# CITY OF ALBUQUERQUE

June 17, 2020

RE: **Lot 1 Block 11 Unit 18 SAD 228  
6604 Petirrojo NW  
Volcano Cliffs Subdivision  
Grading and Drainage Plan  
Engineers Stamp Date 6/15/2020 (D10D003H1)**

DRAWN BY DEM  
DATE 6-15-20  
LOT 1 BK 11 U 18 VOLCANO CLIFFS SUB.  
SHEET # C1  
JOB #

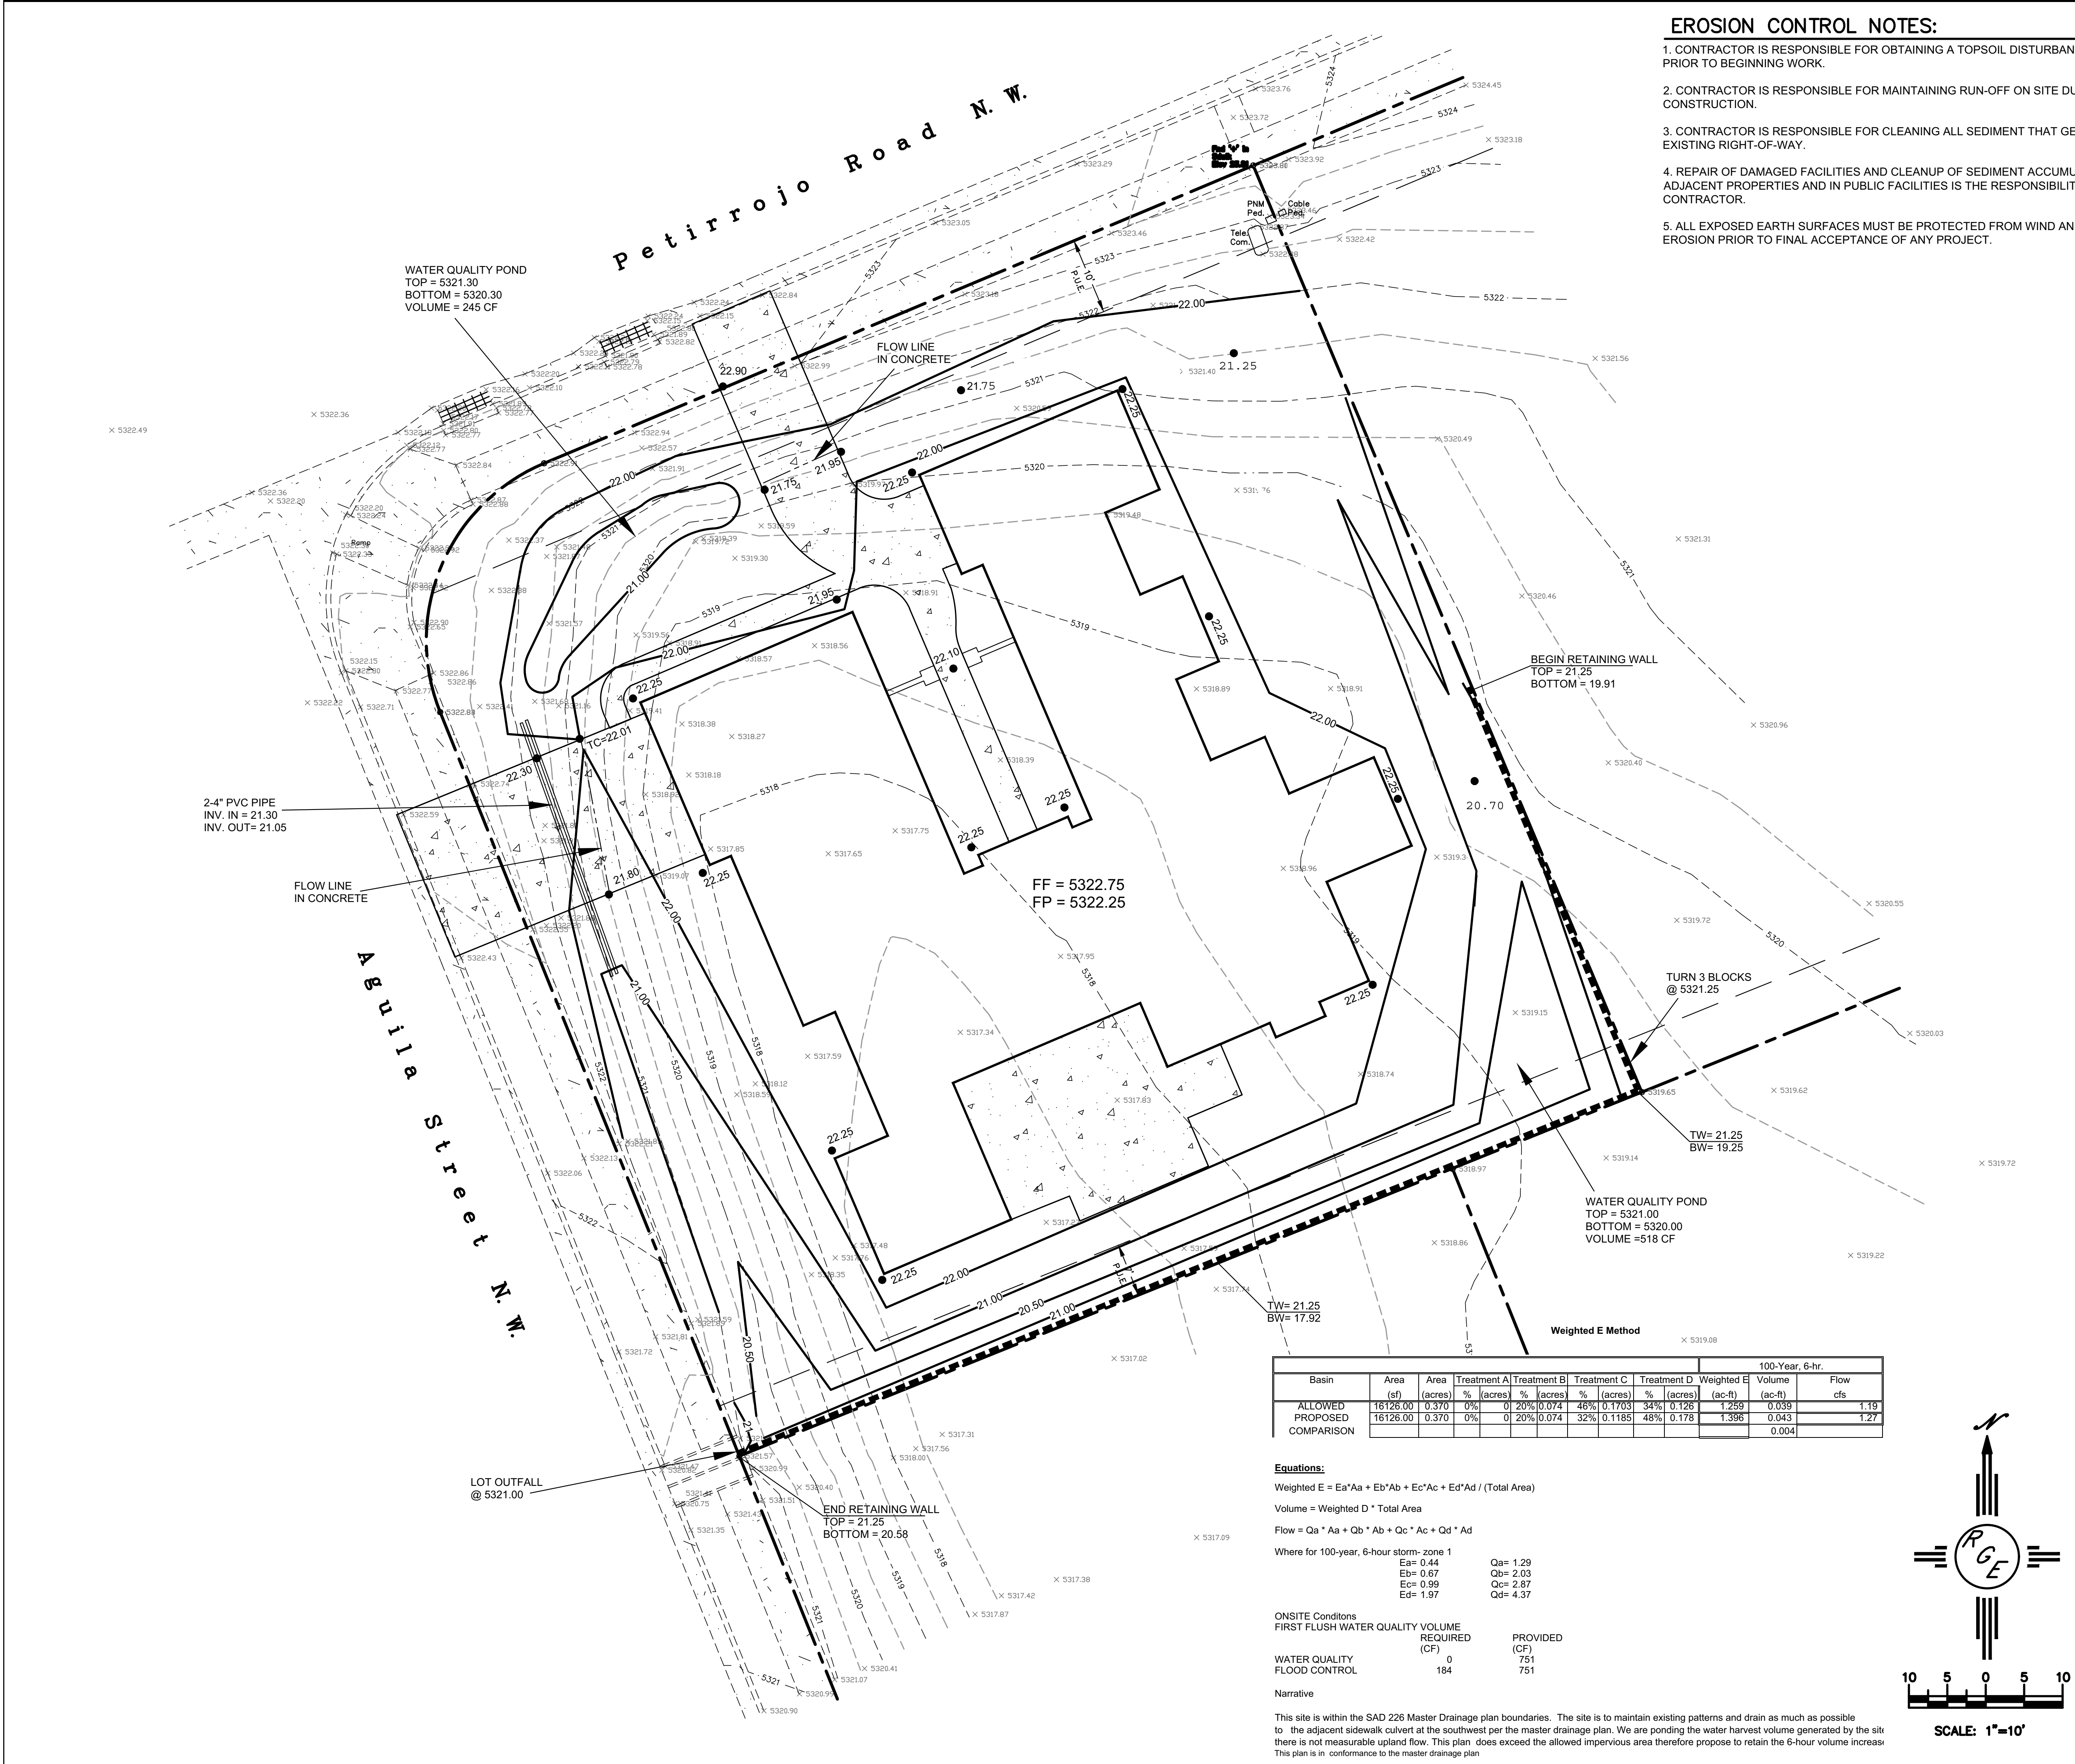
Based upon the information provided in your submittal received 6/17/2020, this plan is approved for Grading Permit.

**Prior to Building permit approval a Pad Certification will be required, provided by the Engineer or a registered Land Surveyor.**

**Advise the owner contractor not to use dirt as a ramp to climb the curb, use lumber or crusher fines for this purpose.**

Reiterate to the Owner/Contractor that a separate permit for a garden/retaining wall must be obtained with the approved G&D plan and Pad Certification. Also, if a swimming pool is to be placed the grading and drainage plan will change and will need to be resubmitted.

**Prior to Certificate of Occupancy release, Engineer Certification per the DPM checklist is required.**
